Service Kit No. SK-109A  
(Supersedes Service Kit No. SK-109)

DATE: December 7, 1970

TITLE: Spinner/Back Plate Modification

Figure 1. Backplate and Forward Cowl Clearance Dimensions.

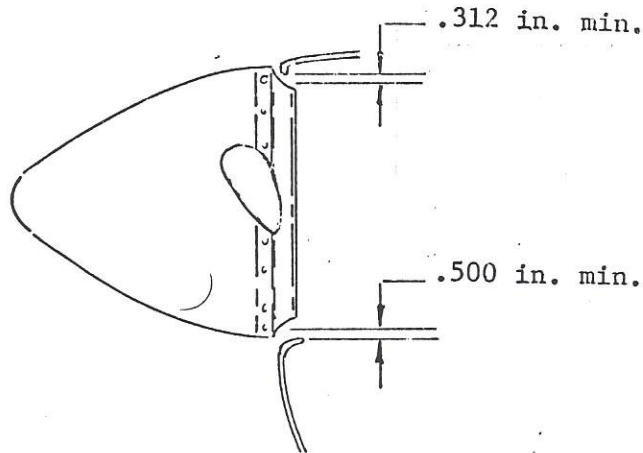
NOTE: If the static clearance between the backplate and forward cowl complies with the dimensions shown below, disregard items 2 thru 6 in this section.

Figure 2. Engine Mount Torque and Dimensions.

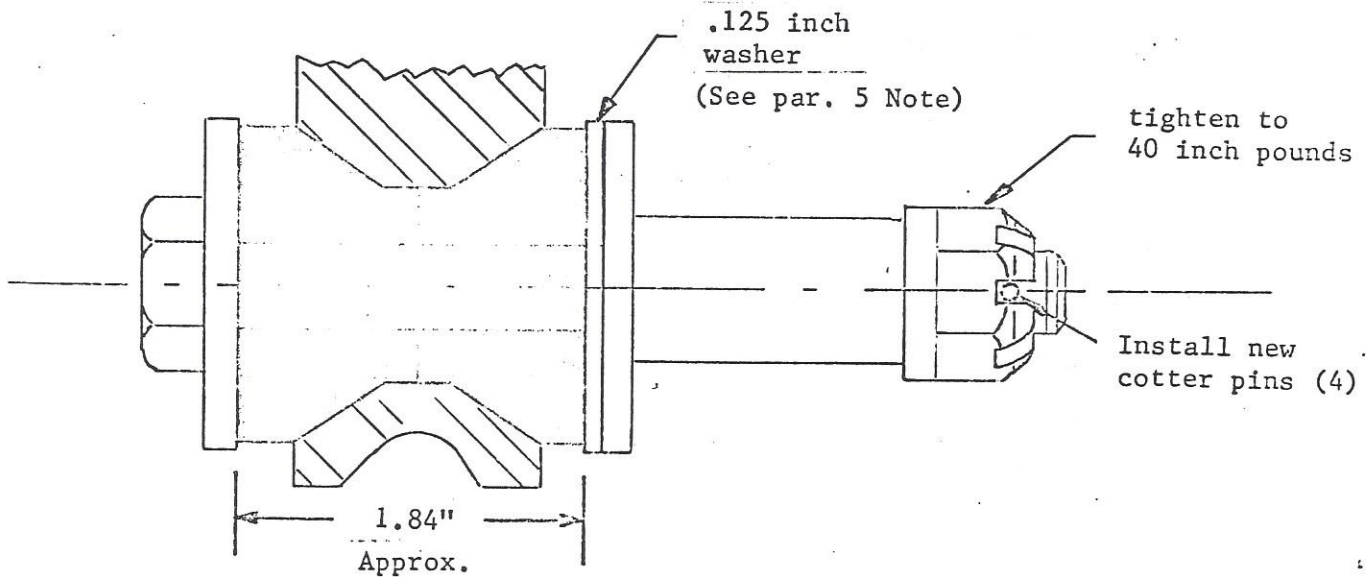
2. Remove upper engine cowling and four (4) cotter pins which lock the nuts at the engine to engine mount attach points.
3. Torque the four (4) engine attach nuts to 40 inch pounds. This should result in a compression of the engine mount bushings to approximately 1.84 inches, as shown below.

NOTE: On some aircraft, a .125 inch washer is installed between the engine mount and the engine support bushing (See fig. 2) on the lower mounts only. If these washers are presently installed, reinstall them in the same position.

Figure 3. Upper flange dimension

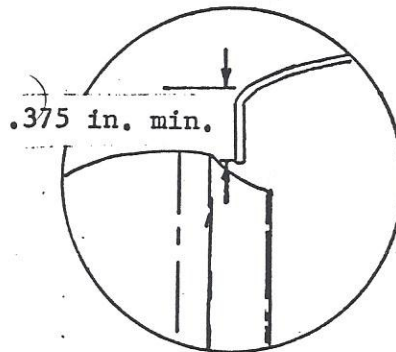
- If the static clearance between the backplate and upper forward cowl is less than .312 inch, relieve the top flange of the forward cowl to provide .312 inch clearance.

CAUTION: Do not relieve the top flange of the forward cowl to less than .375 inch from the lower edge of the flange to the upper radius (See figure 3).

Figure 4. Backplate clean-up.

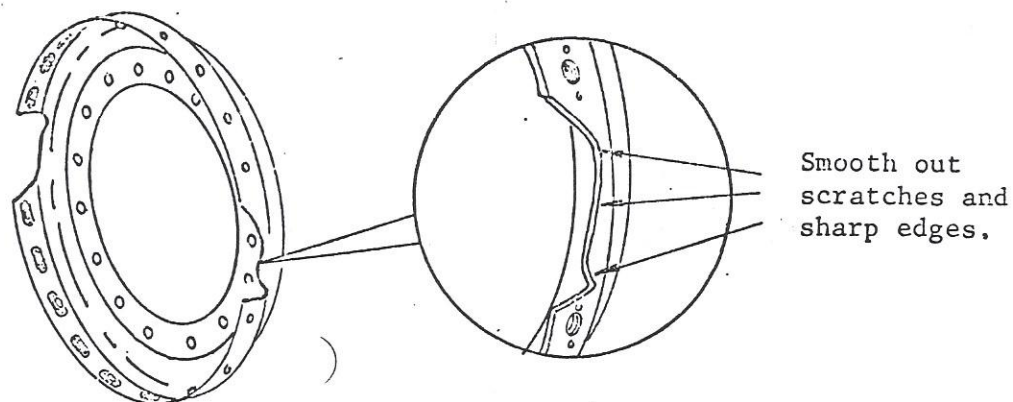
- Remove the twelve (12) backplate attaching nuts and washers and remove the backplate.
- Carefully smooth out the propeller cutout areas in the back plate as shown on figure 4. These areas should be sufficiently smoothed to eliminate all scratches and sharp edges. NOTE: If cracks are found in backplate, it must be replaced. Replacement backplates will have doublers installed.

Figure 5. Doubler Installation

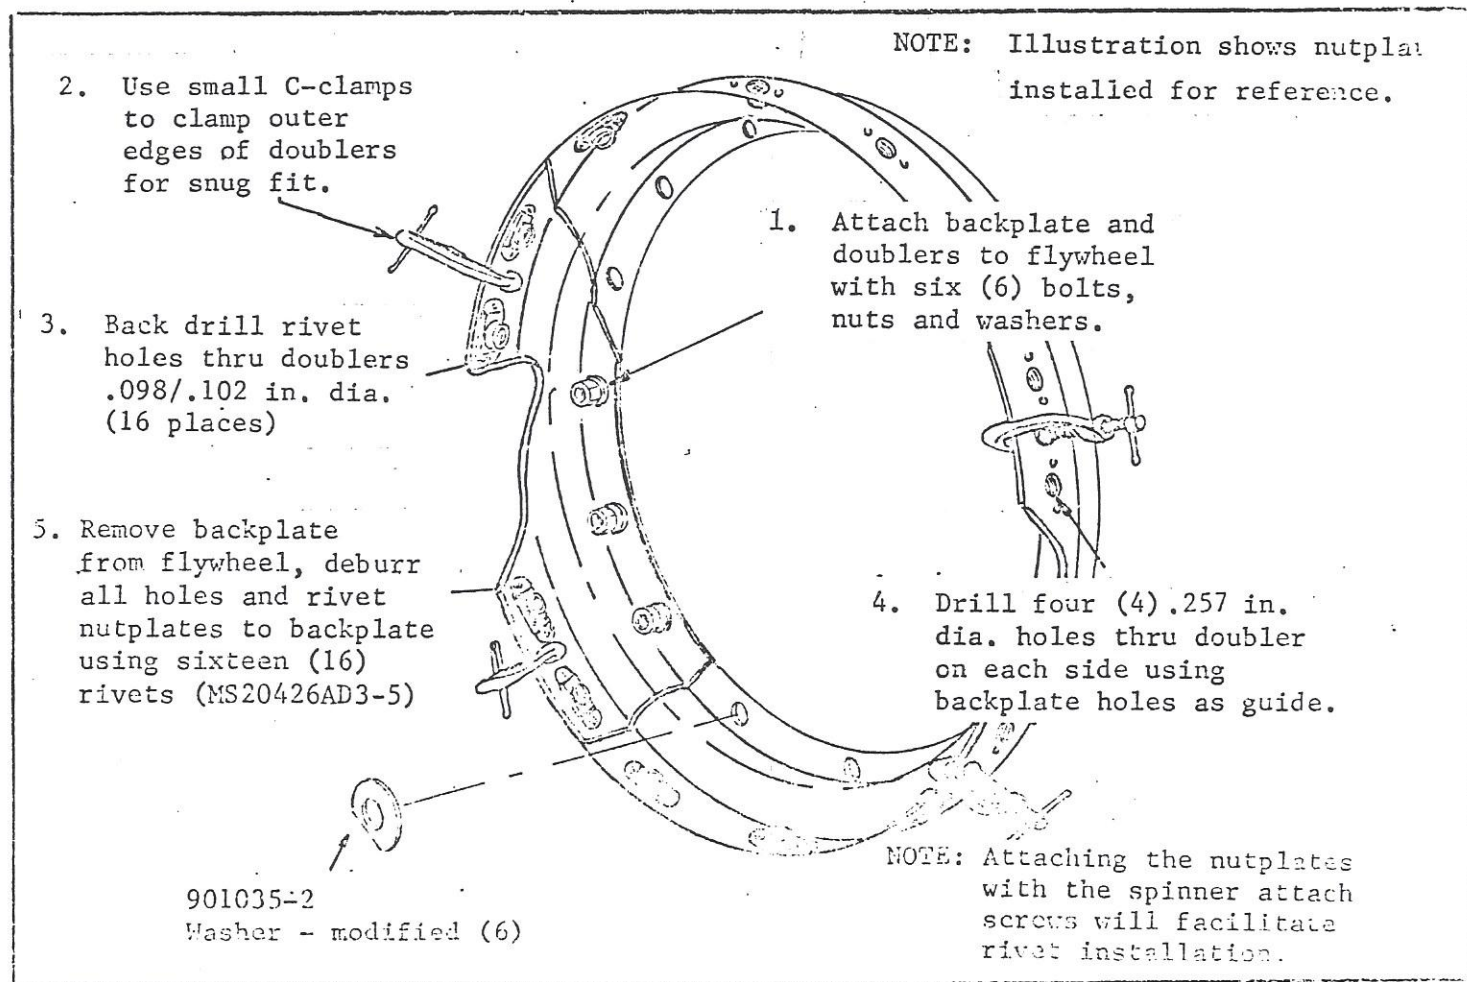
4. Refer to figure 5 and drill out the rivets that attach the eight (8) nut plates to the backplate (Two (2) nutplates adjacent to each cutout - both sides). Save the eight (8) nutplates.
5. Position the two (2) doublers (506004-2) in the backplate and attach the backplate to the ring gear support assembly using six (6) bolts, nuts and washers. Using small C-clamps, clamp the outer edges of the doublers to the backplate.

10. Install the modified backplate to the engine exactly as removed, with the exception that six (6) washers - modified (part number 901035-2) are to be located against the forward face of the backplate not covered by the doublers and one (1) AN960-416 washer is to be used on top of each modified washer. Be sure to locate the trimmed edge of the modified washers adjacent to the radius in the backplate as shown on figure 5.

Figure 6. Drain Hole Locations.

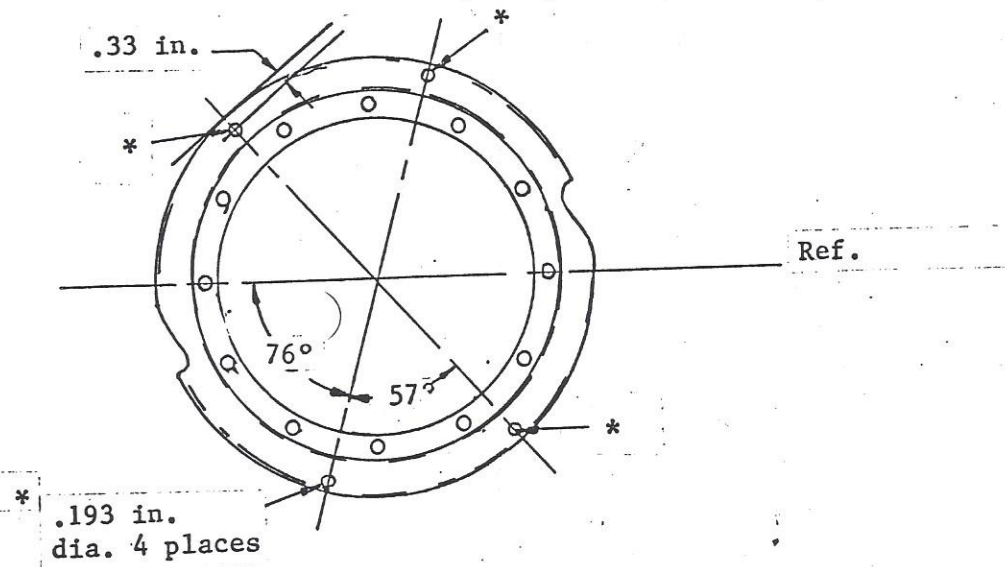
6. Locate and drill four (4) .193 in. dia. drain holes in the backplate as shown on figure 6 and as instructed in paragraphs 7, 8 and 9.

7. Place the backplate on a flat surface as shown on figure 6 and place a straight edge across the centers of the first hole above the left propeller cutout and the first hole below the right propeller cutout. Mark a line across these points for reference.

8. Using a protractor, mark a line at 76° from reference line, then a line at 57° from the 76° line (See figure 6).
9. Drill four (4) .193 in. dia. holes .33 inches in from outer flange as shown on figure 6. Deburr holes.

Figure 7. Spinner cutout cleanup.

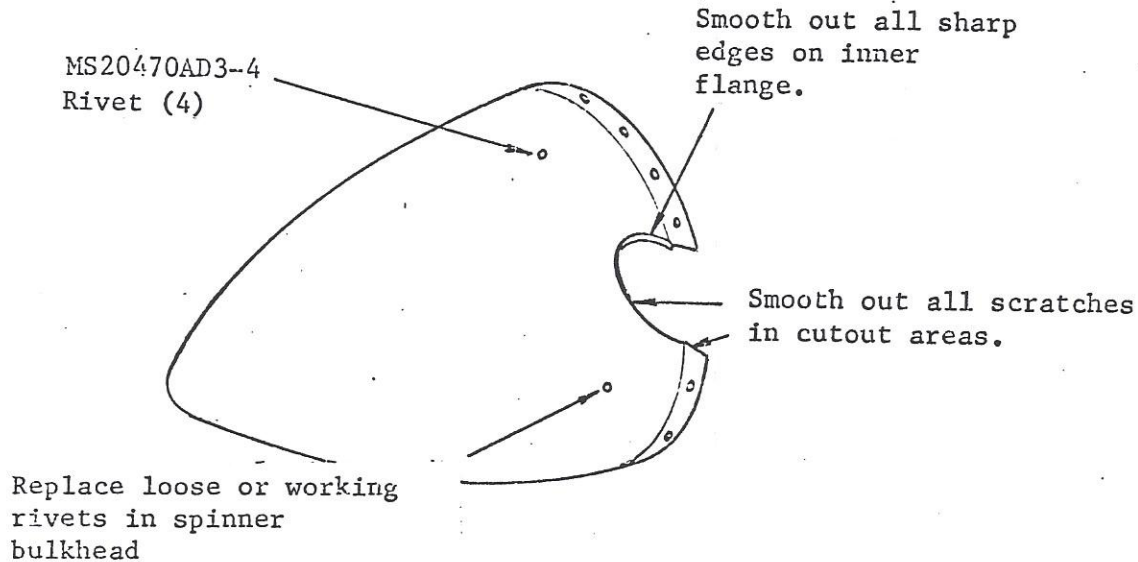
1. If loose or working rivets were found in the spinner bulkhead, replace rivets as necessary with MS20470AD3-4 rivets supplied with this kit.
2. Carefully smooth the propeller cutout areas in the spinner as shown below. These areas should be smoothed enough to remove all scratches and sharp edges.
